ADDENDUM
NO. 03

February 19, 2026

Edwardsburg Public Schools – Middle School and High School Mechanical Upgrades

This Addendum consists of Pages ADD 3-6 through ADD 3-3, and TowerPinkster Addendum No. 03 Middle School Mechanical Upgrades, consisting on 60 pages, and TowerPinkster Addendum No. 03 High School Mechanical Upgrades, consisting of 48 pages.

FIRST FLOOR LIGHTING PLAN - UNIT D - ALTERNATE #2

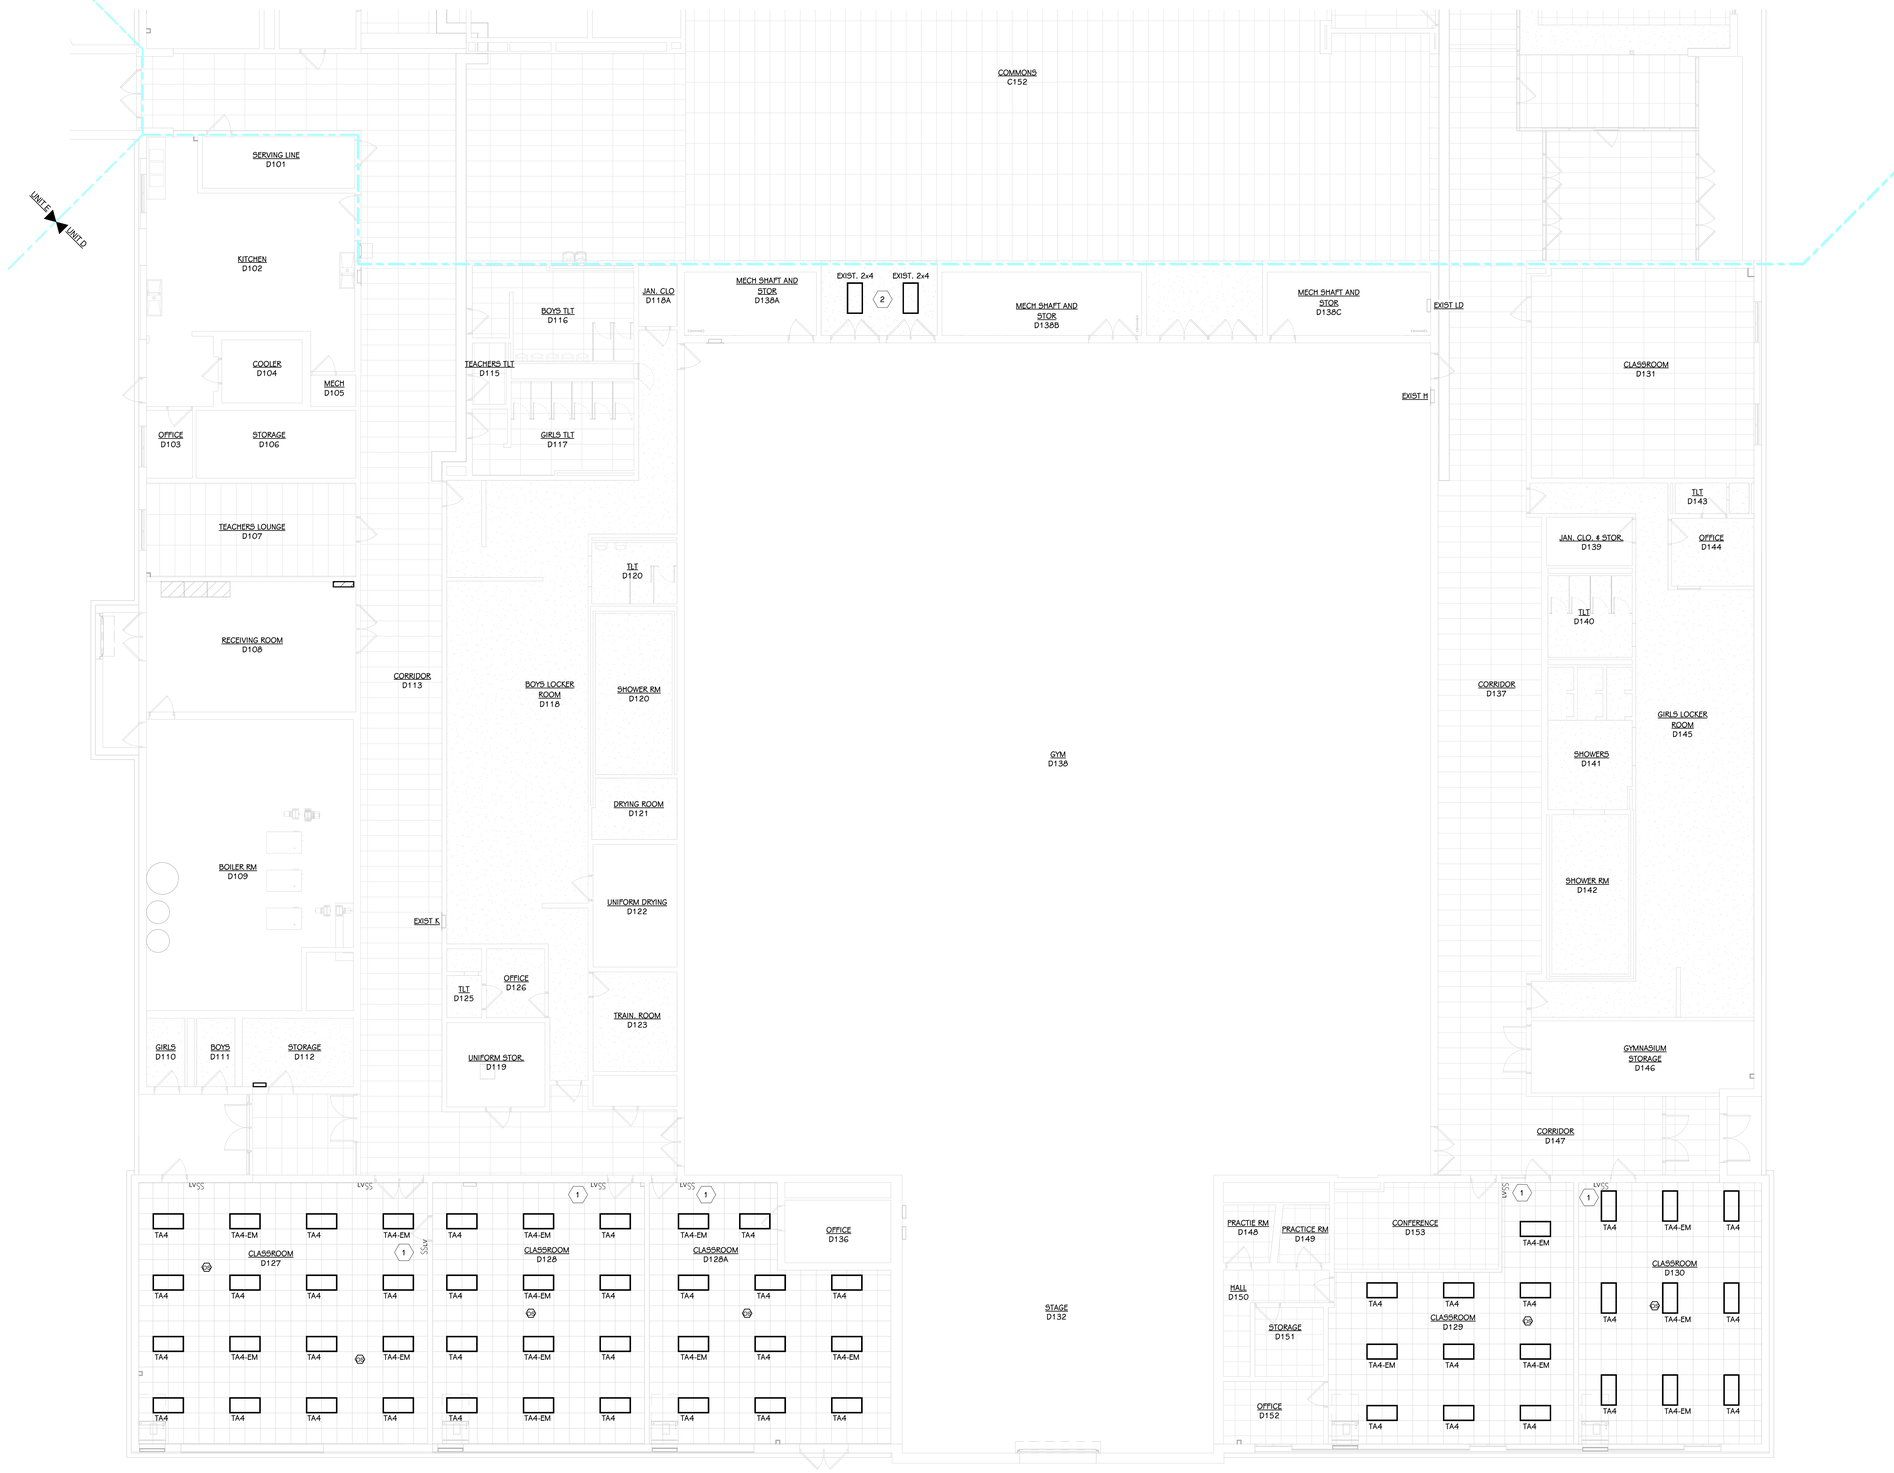
Added a note describing the base bid work for lighting and changed the new lighting drawing titles to include Alternate #2 to clarify base bid vs alternate work. Moved lighting in the mechanical mezzanine from Drawing E 201D to E 101D and added a note to show that it is part of the base bid work. Moved the lighting fixture schedule from drawing E 402 to drawing E 420 and noted that fixture type WLA is part of the base bid. Refer to drawing ED 201D for base bid vs alternate note, drawing E 101D for mechanical mezzanine base bid lighting, E 201D and E 420 for Alternate #2 work. Refer to G 001 for updated drawing index.
